Service bulletin

C. 17/65

INHIBITOR SWITCH BOSS ON TRANSMISSION CASE

BORG-WARNER
AUTOMATIC
TRANSMISSION
MODEL 35

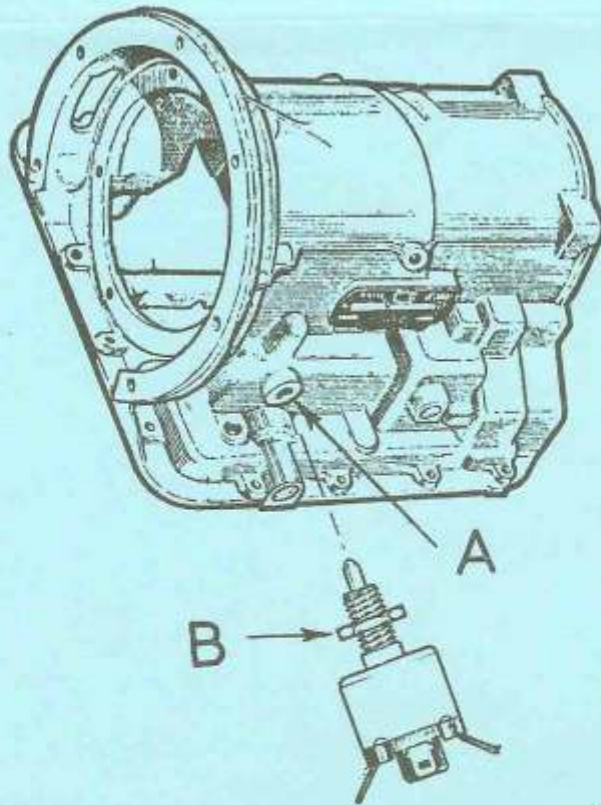
A few transmissions were produced recently with .030" excess material on switch boss 'A' of the transmission case.

Should difficulty be experienced in obtaining adjustment of the inhibitor switch, reduce the thickness of the switch locknut 'B' by .030".
